**AGENDA FOR THE REGULAR MEETING OF THE
MIDWEST CITY**

**PLANNING COMMISSION
September 1, 2020 – 7:00 p.m.
City Council Chambers
City Hall
100 North Midwest Boulevard**

4. (PC – 2051) Discussion and consideration of approval of the proposed preliminary plat of The Curve, described as a part of the SW/4 of Section 8, T11N, R1W, located at 11004 SE 28th Street.

PRELIMINARY PLAN
FINAL REVIEW
TREE CANOPY MANAGEMENT PLAN
PRE-DEVELOPMENT
L-101
SHEET NO. 1 OF 3
DATE: 08/21/20
PROJECT NO. 20607900

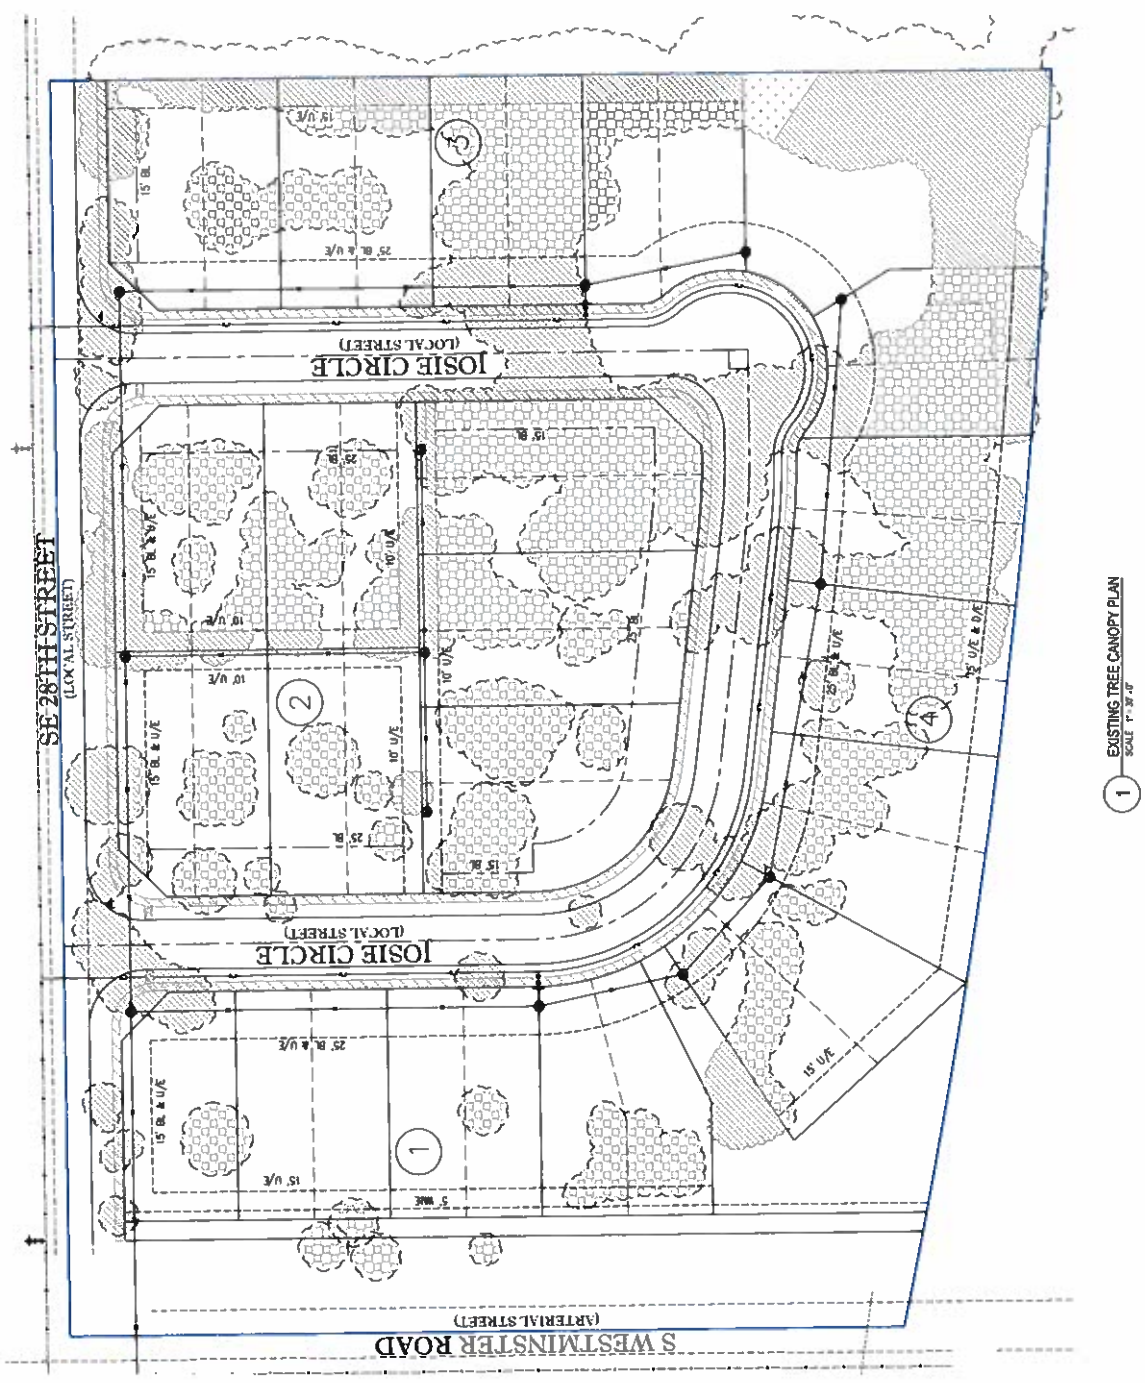
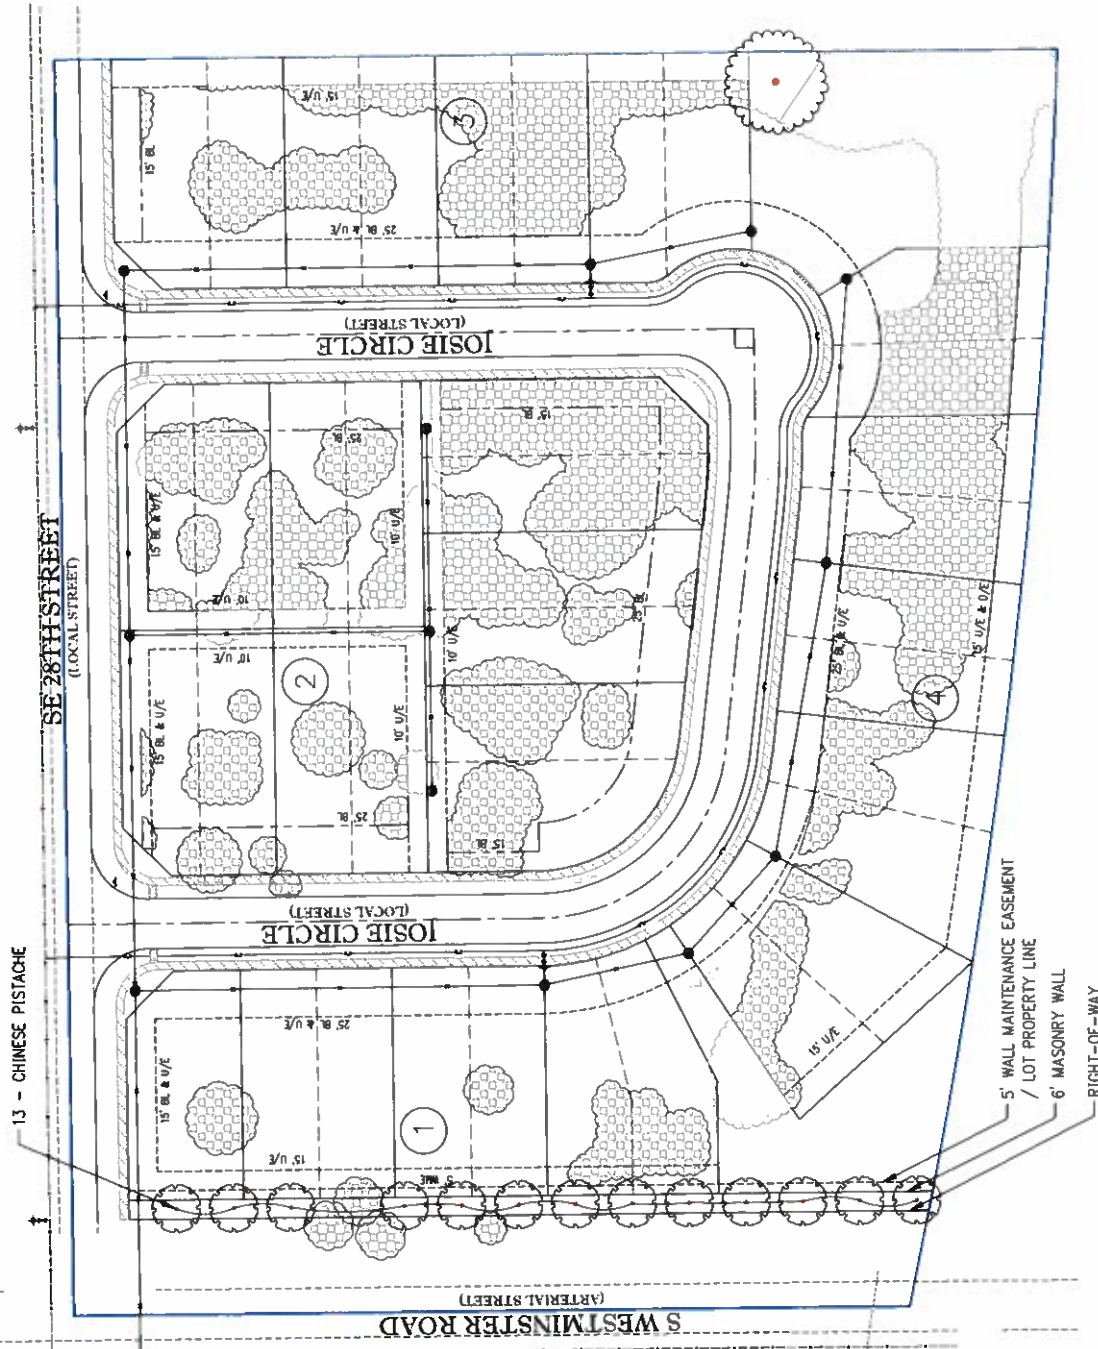
As required under section 38-53.4 of the 2012 Midwest City Subdivision Regulations, the applicant has prepared and submitted a Tree Canopy Management Plan. The applicant has chosen to pursue Option A which means that trees will be removed from areas dedicated for infrastructure such as utilities, drainage and the road. All other trees must remain throughout the platting process.

As the area of request has frontage on an arterial street, S. Westminster, Thoroughfare Screening is required by Section 38-46 of the Subdivision Regulations. The landscape plan shows a proposed 6' masonry wall along the back of the lots backing onto Westminster as well as landscaping of 13 Chinese Pistache trees.

PRELIMINARY DRAINAGE PLAN

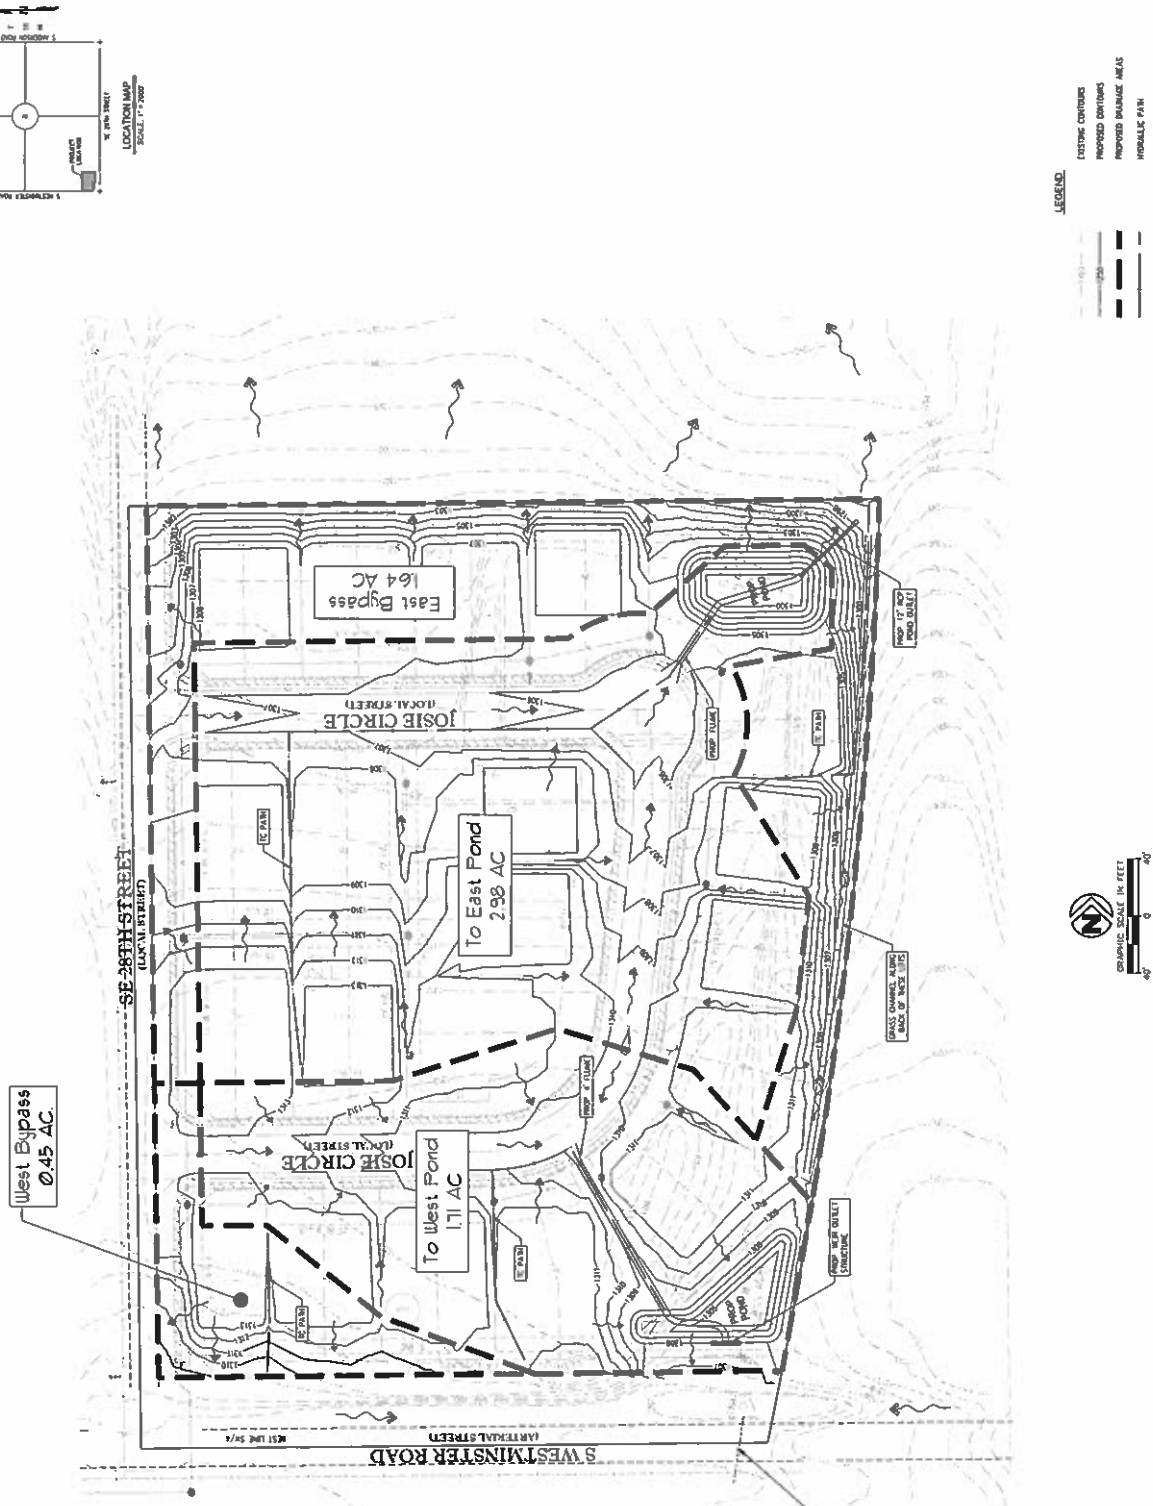
- A detention pond in the southwest portion serving Basin 1 would accept 1.71 acres (25% of the 6.77 total drainage acreage). The detention pond will outflow via a piped weir to the southwest corner of the property and onto Westminster Road right of way, just upstream of an existing cross drain. In construction plans we would ask that the development consider tying the systems together at a junction box.

- Bypass areas (31% of drainage acreage)
 - 0.45 acres are proposed to sheet flow directly onto Westminster Road right of way and into the city's existing ditch.

- 1.64 acres are proposed to sheet flow directly to the neighboring property to the east.
 - The back yards of 4 Lots will be flowing directly to the east. Sheet flow will be required.

- The back yards of 4 Lots on the south side are shown as bypass but via flowing across lots. This will not be allowed unless an improved (i.e. concrete) channel is provided for the lots to flow water across the lots. The end of improvement will need to have energy dissipation and allow for water to become distributed into more of a sheet flow.
